PIC18FXX2 Rev. B2 Silicon/Data Sheet Errata

The PIC18FXX2 parts you have received conform functionally to the Device Data Sheet (DS39564B), except for the anomalies described below.

The following silicon errata apply only to PIC18FXX2 devices with these Device/Revision IDs:

FIGURE 1: PINOUT DIAGRAM FOR 44-PIN QFN PACKAGE

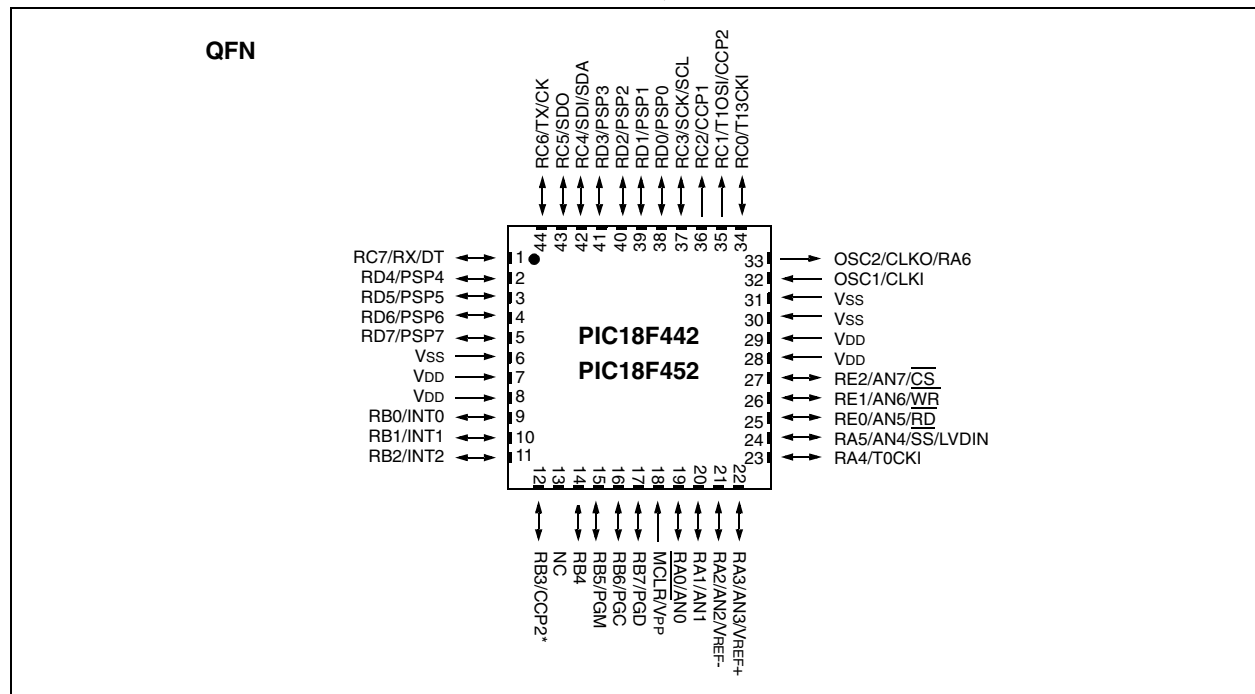
PIC18F442 and PICF452 devices are now offered in 44-pin, near chip-scale micro lead frame packages (commonly known as “QFN”). This packaging type has been added to the product line since the latest revision of the Device Data Sheet.

The addition of this option requires the following additions to the Device Data Sheet (DS39564B). The referenced figures and tables follow this text.

1. The “Pin Diagrams” on pages 2-3 of the Data Sheet are amended with the addition of the 44-pin QFN pinout, shown in Figure 1.
2. Table 1-3 of **Section 1.0 “Overview”** is replaced with an updated version which adds a column for QFN pin assignments. A row is also added for previously unlisted NC pins. All new information is indicated in **bold**.

FIGURE 1: PACKAGE MARKING TEMPLATE FOR PIC18F442/452, 44-PIN QFN

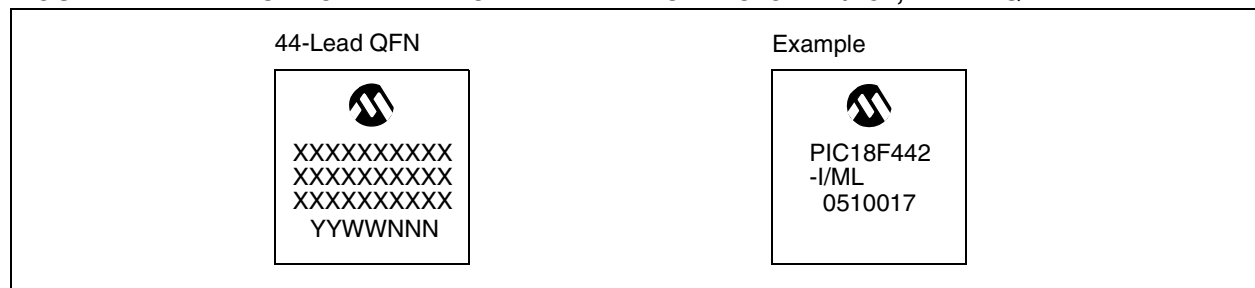
3. **Section 24.1 “Package Marking Information”** is amended to include a marking template and example for 44-pin QFN devices. These are shown in Figure 1.

FIGURE 2: 44-PIN QFN PACKAGE

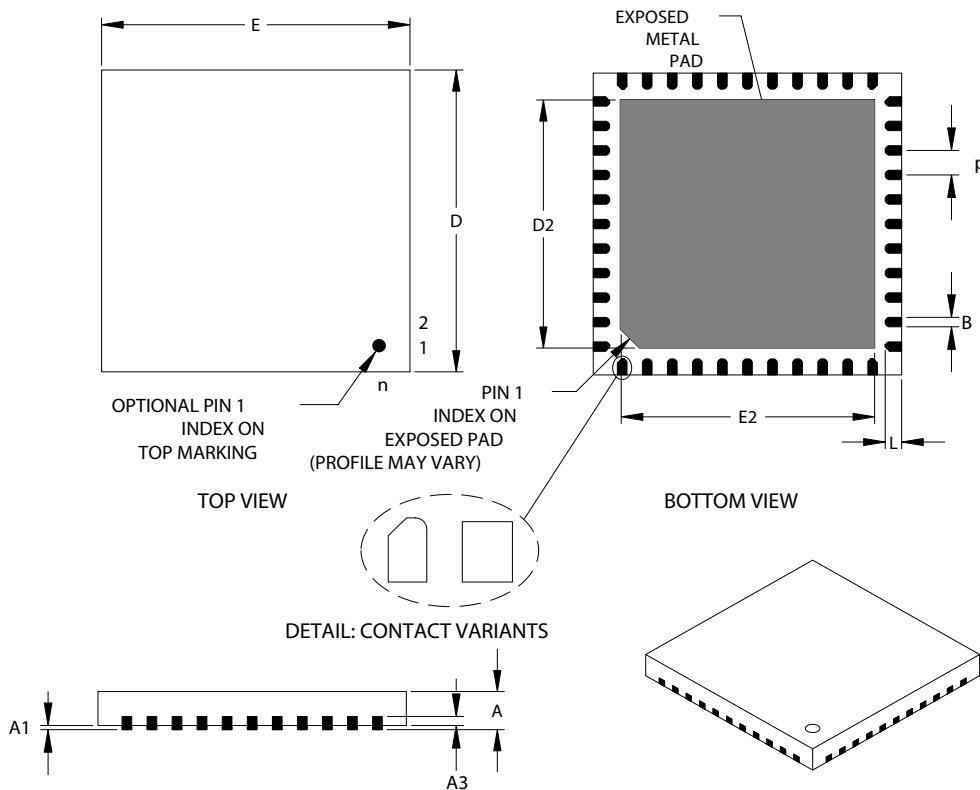
4. **Section 24.2 “Package Details”** is amended to include the mechanical drawing of the 44-pin QFN package following the existing drawings. This is shown in Figure 2.
